From: Simon Wilson [REDACTED]
Sent: 31 July 2026 20:37
To: James, Jonathan <Jonathan.James@wiltshire.gov.uk>; Matt Tucker [REDACTED]
Subject: RE: PL/2026/03581 - DoC Rose Villa, Roundway

Please find below our response to LLFA comments with regards to Rose Villa, Roundway (PL/2026/03581).

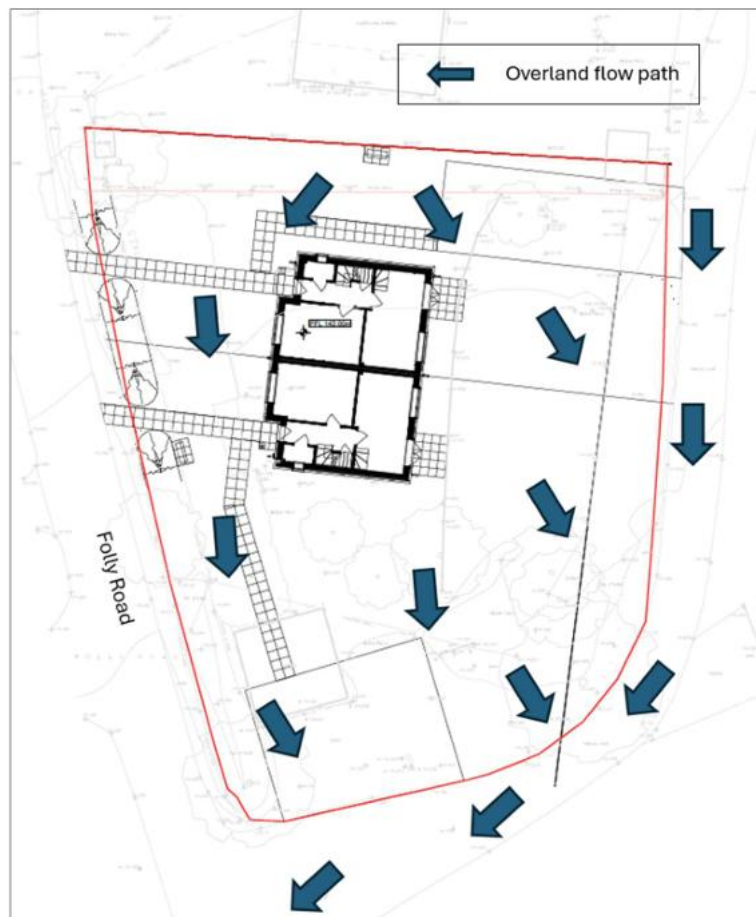
- The submitted strategy relies upon infiltration, notwithstanding the submitted ground investigation and infiltration testing which indicated that infiltration drainage may not be feasible. Please provide further technical justification demonstrating that the proposed drainage system will operate effectively, including evidence to justify the infiltration assumptions used within the drainage calculations and confirmation that the system can adequately accommodate successive rainfall events.

By combining the restricted flow rate and discharge to soakaway, it must be noted that the outflow would be less than 0.0l/s up to the 1 in 100 year + 45% climate change – See below.

As noted in the drainage strategy report, we are looking to attenuate flows as close to greenfield run-off as possible (as per the current scenario) at 0.5l/sec for up to the 1 in 100-year event + climate change, whilst not introducing risk of flooding through blockage risk at the flow control.

By discharging the resultant flow to ground through a soakaway, we would be mimicking as close as feasible the current scenario. It is appreciated that the results from the ground investigation resulted in a failed test in accordance with BRE Digest 365, but clearly there is infiltration, albeit slow, as there has been no reports of surface water flooding at the site, and neighbouring properties are also likely discharging to ground without a flow control.

In lieu of a usable infiltration rate through ground investigations, we have used 1×10^{-6} m/s which is a rate referenced within the National Standard for SuDS (section 3.14) as being the limit for infiltration features.

Results for 100 year +45% CC Critical Storm Duration. Lowest mass balance: 91.28%

Node Event	US Node	Peak (mins)	Level (m)	Depth (m)	Inflow (l/s)	Node Vol (m³)	Flood (m³)	Status
60 minute winter	Geocellular (plot 1)	49	141.961	0.712	2.0	1.6320	0.0000	FLOOD RISK
600 minute winter	Geocellular (plot 2)	570	141.556	0.896	0.4	1.6373	0.0000	FLOOD RISK
600 minute winter	Soakaway (offsite)	585	141.546	0.899	0.5	6.7823	0.0000	OK

Link Event (Upstream Depth)	US Node	Link	DS Node	Outflow (l/s)	Velocity (m/s)	Flow/Cap	Link Vol (m³)
60 minute winter	Geocellular (plot 1)	plot 1	Soakaway (offsite)	0.5	1.054	0.022	0.0006
600 minute winter	Geocellular (plot 2)	plot 2	Soakaway (offsite)	0.5	0.354	0.085	0.0101
600 minute winter	Soakaway (offsite)	Infiltration		0.0
